HISTORIC AND DESIGN REVIEW COMMISSION

November 17, 2021

HDRC CASE NO: 2021-373
ADDRESS: 3215 ROOSEVELT AVE
LEGAL DESCRIPTION: NCB 11918 BLK 14 LOT 9 J WEISS SUBD
ZONING: C-1, H
CITY COUNCIL DIST.: 3
DISTRICT: Mission Historic District
APPLICANT: DOUGLAS CAFFEY/EMPIRE CANOPY SIGN AND CONSTRUCTION
OWNER: ROOSEVELT REALESTATE GROUP INC
TYPE OF WORK: Signage
APPLICATION RECEIVED: October 21, 2021
60-DAY REVIEW: Not applicable due to City Council Emergency Orders
CASE MANAGER: Edward Hall

Premium Gas Canopy

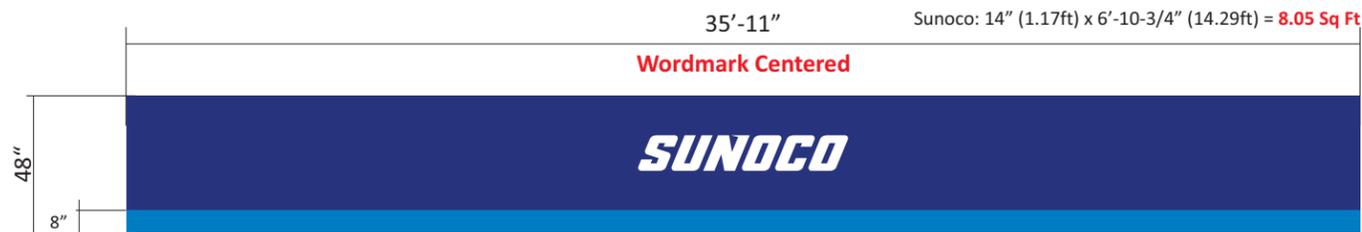
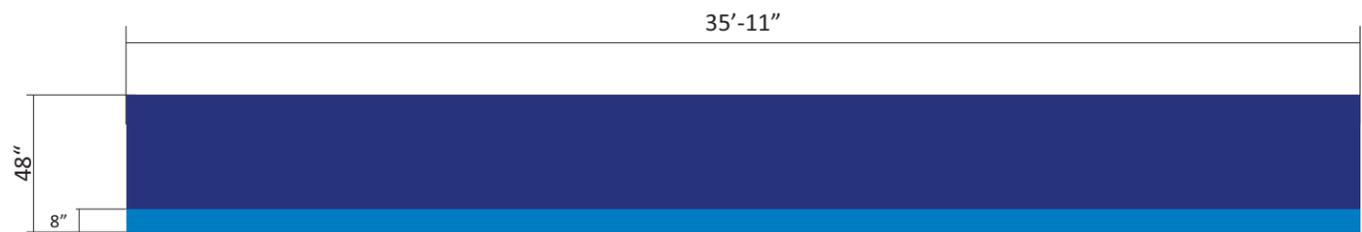
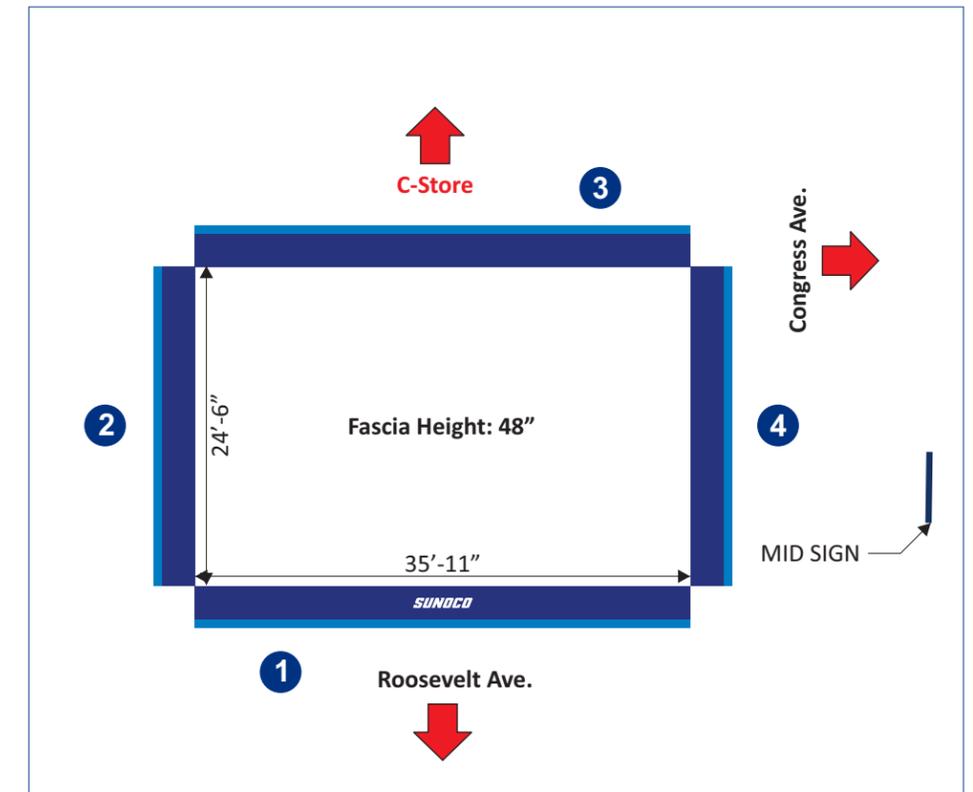
- d. PREVIOUSLY APPROVED SIGNAGE – Monument signage and fuel pump graphics were approved by the HDRC with stipulations on October 20, 2021.
- e. FASCIA SIGNAGE – The applicant has proposed to install a signage fascia on each side of the existing fuel canopy. The signage fascia will rear “Sunoco” on the front (east) elevations in flat, non-illuminated letters. Other elevations will only feature new panels with no signage. The proposed signage fascia would feature a length of approximately thirty-six (36) feet on the east and west elevations and approximately 24’ – 6” on the north and south elevations. The application notes that the existing canopy flood lights may be used to illuminate the fascia signage.

Staff recommends approval of the proposed signage based on finding e with the stipulation that the signage be located on either the north or south façade as to not face directly toward Mission San Jose.
